From: Watkins, Robert
Sent: Thursday, February 17, 2022 7:54 AM
To: robmcginnis@me.com
Cc: Werner, Jeffrey B
Subject: February BAR Action - 413 Ridge Street

Certificate of Appropriateness

BAR 22-02-03
511 N 1st Street, TMP 330001000
North Downtown ADC District
Owner: Charlottesville Towers Condo Assoc.
Applicant: Robert McGinnis
Project: Alterations to main entry.

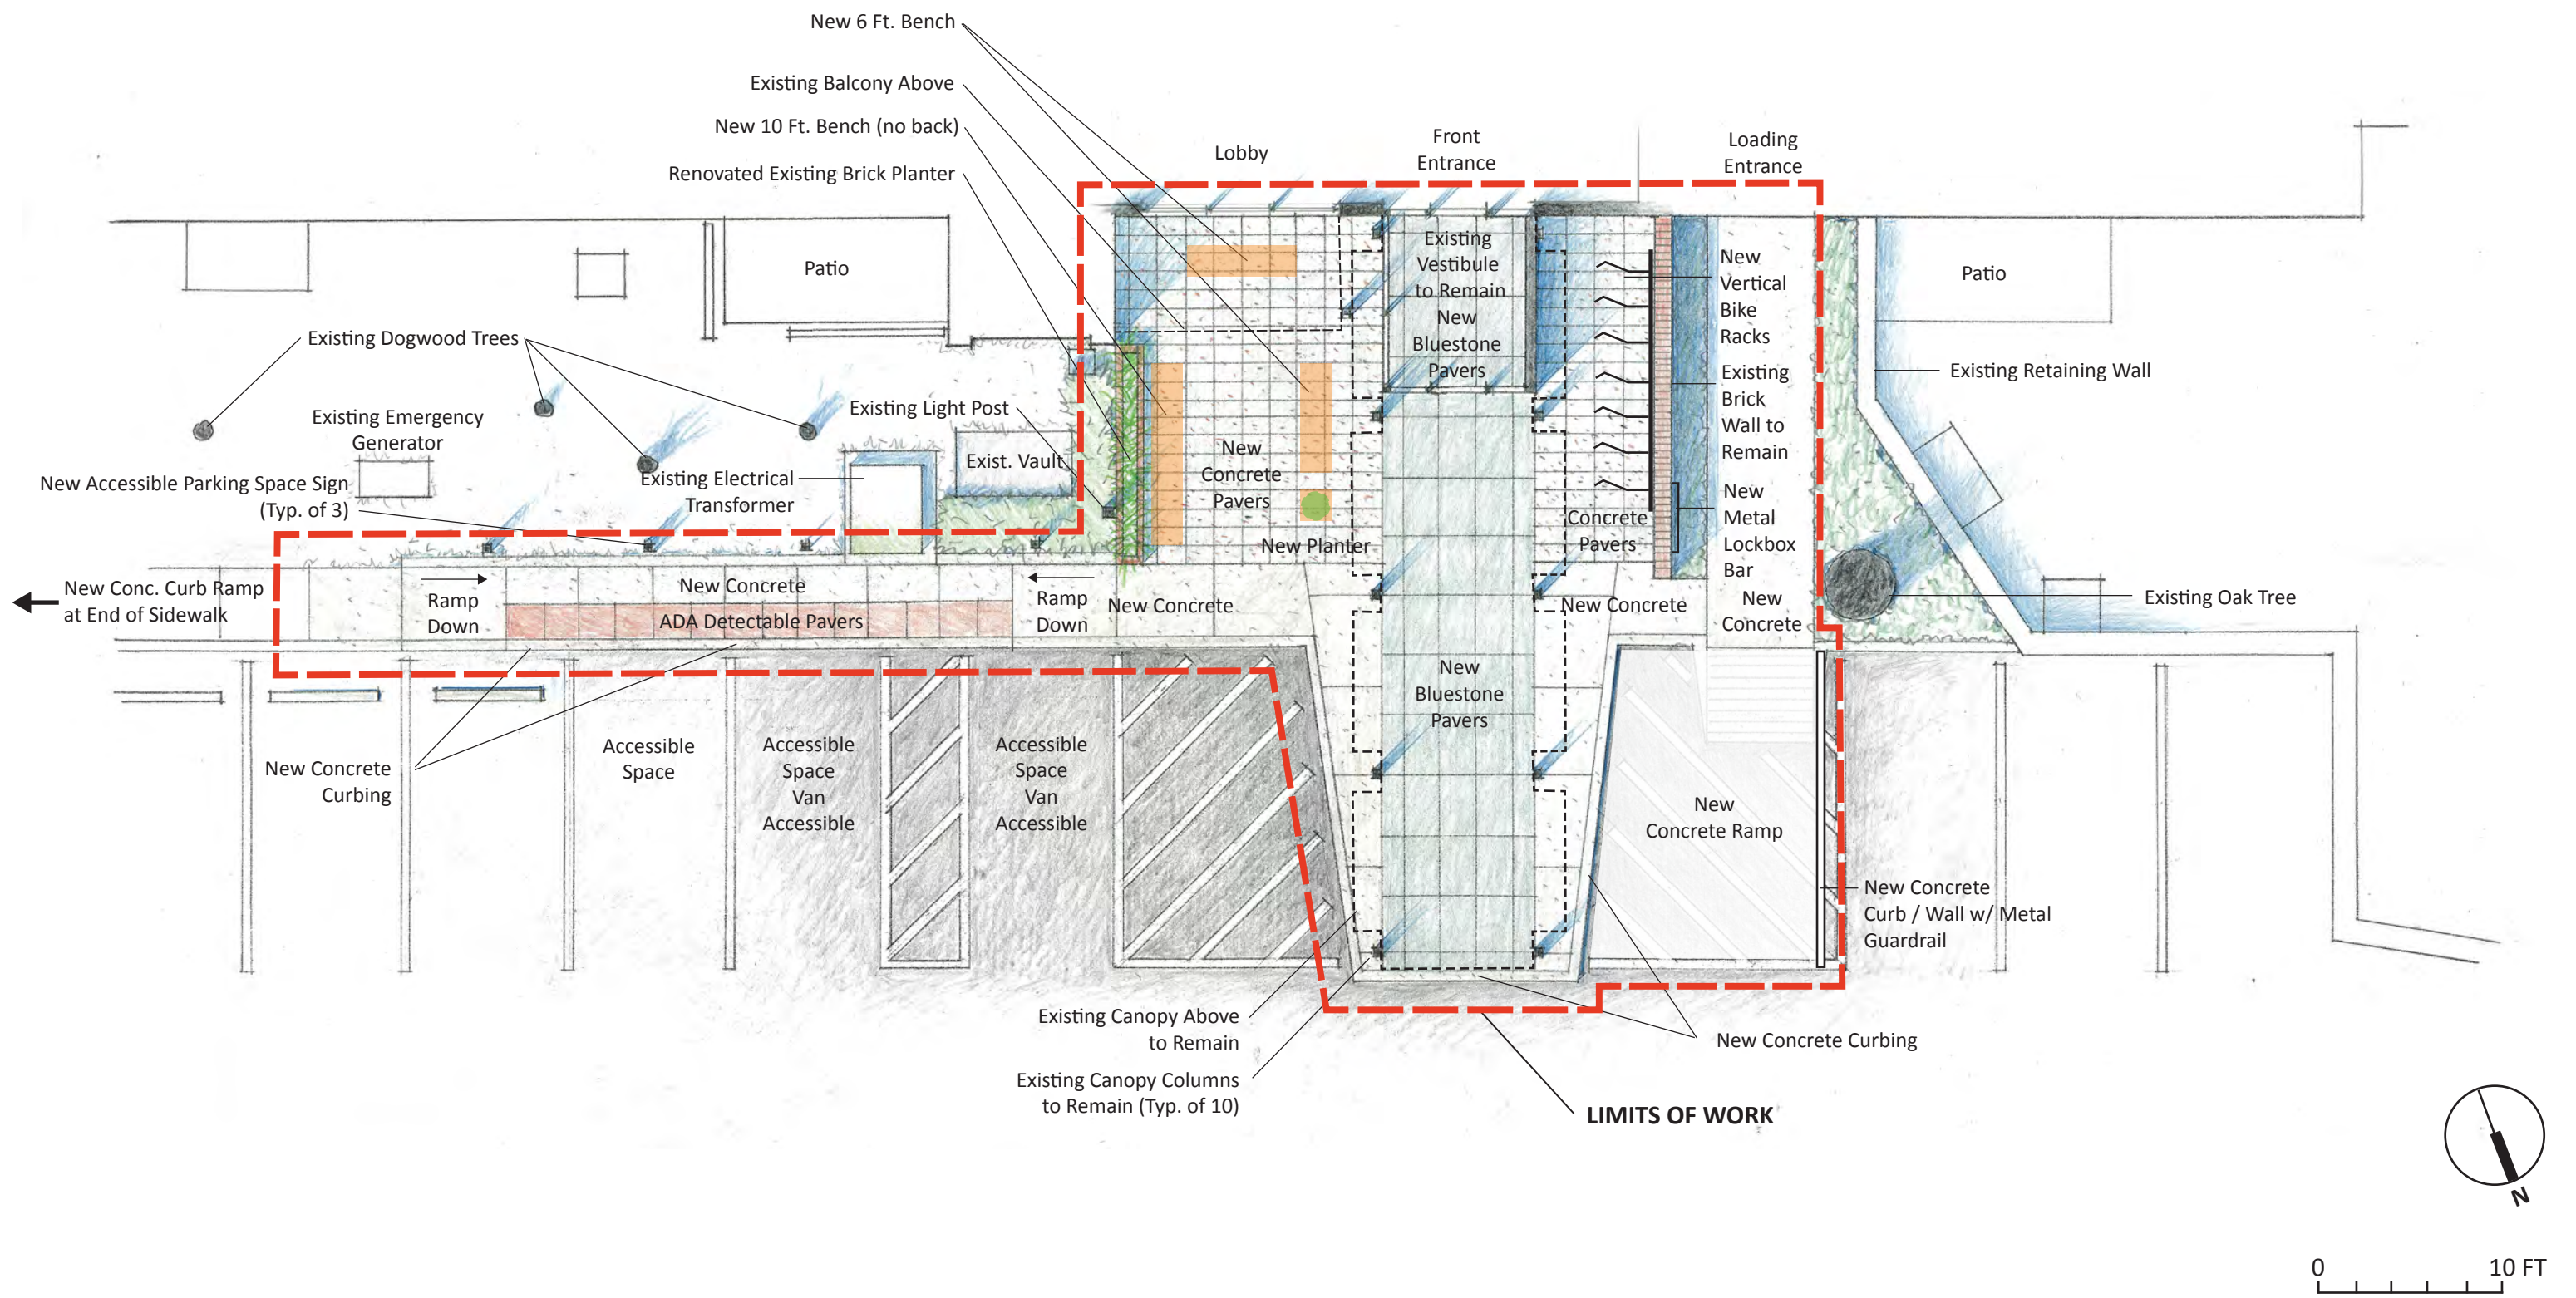
RAMP IS DANGEROUS TO NAVIGATE

RAMP IS DANGEROUS TO NAVIGATE

CERAMIC TILES ARE SLIP HAZARDS; TILES ARE LIFTING UP

CERAMIC TILES ARE SLIP HAZARDS; BEVELED EDGES ARE NOT ADA-COMPLIANT; PAVING AT BASE OF CANOPY POST FAILING

CURB RAMP IS NOT ADA-COMPLIANT

TOP SURFACE ELEVATION OF TILE AND ABUTTING PAVING DOES NOT MATCH

SPACE OF PASSAGE OF BIKES IS TIGHT

CURB RAMP IS NOT ADA-COMPLIANT

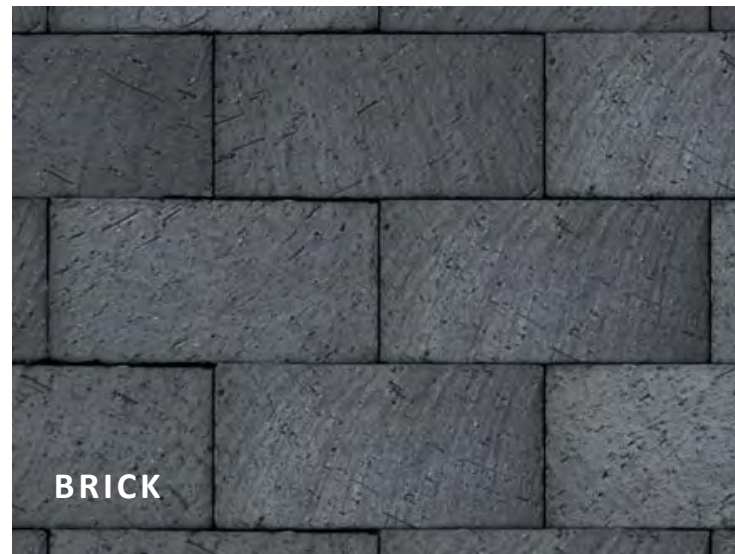
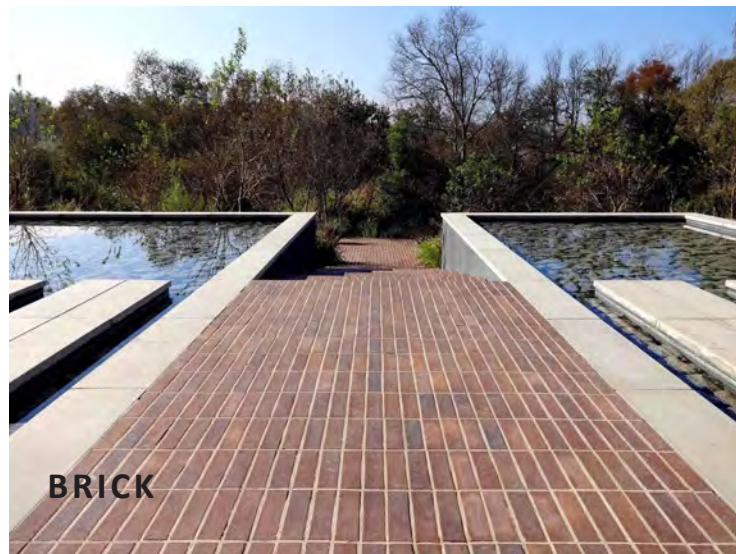
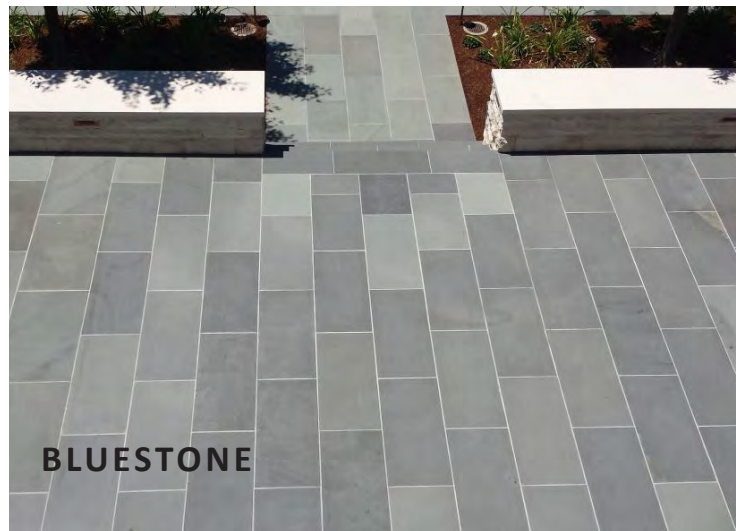
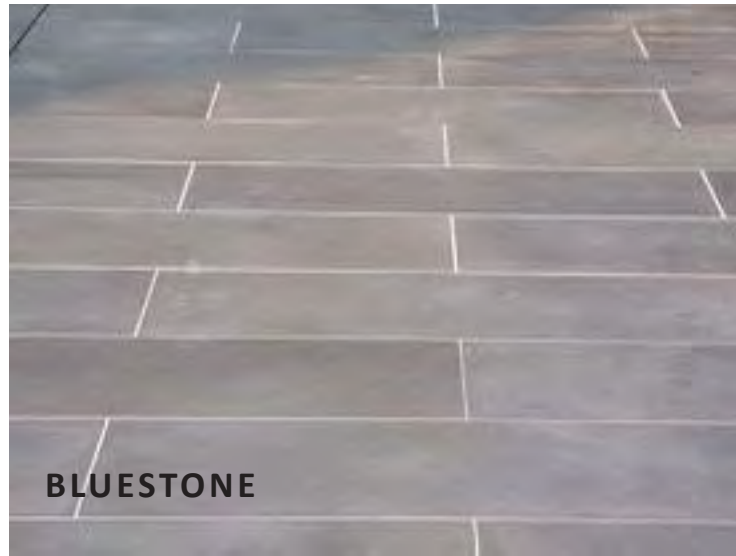
CHANGE IN LEVEL AT WALK JOINTS DOES NOT COMPLY WITH ADA REQUIREMENTS

ACCESSIBLE PARKING SPACE SIGNS SUBJECT TO DAMAGE FROM VEHICLES
